Access Compliance Report Public Rights-of-Way (RR Crossings)

Intersection ID: 12779	Main Street: E_TRADE_ST	Location: N/A
ADA ID: 78177D3F07D5	Overall Compliance: No	Severity Score: 0.0
Codes/Mitigation Info/Possible Solution		Field Measurements/Component Compliance

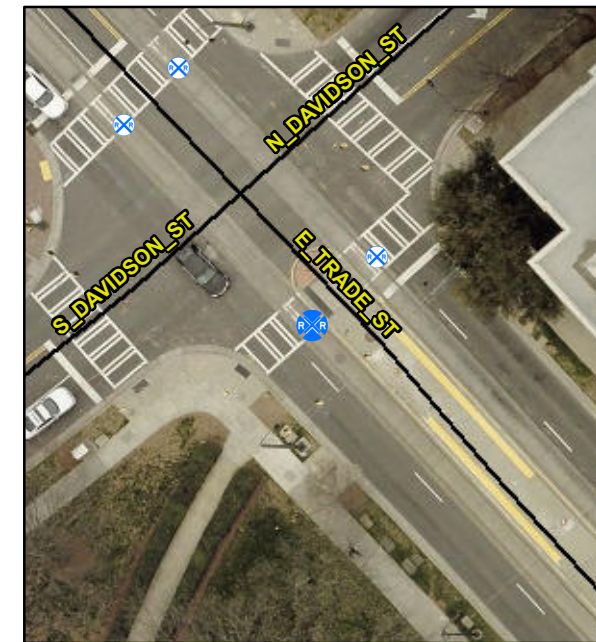
**LIGHTRAIL IN STREET WITH
MEDIAN REFUGE ON ONE SIDE**

Compliance	Description	Data
Yes	DWS Provided?	Yes
Yes	DWS Contrast?	Yes
Yes	DWS Width (in)	Yes
Yes	DWS Length (in)	25.0
No	DWS Offset (in)	25.0
No	Pedestrian Gate?	No
N/A	DWS Outside Gate?	No
N/A	Rail Type?	LightRail
No	Flangeway Gap (in)	2.5
Yes	Sidewalk Width (in)	113.0

**Remove & Replace Detectable
Warning System. Provide Pedestrian
Gate. Remove & Replace Walking
Surface Adjacent to Rail.**
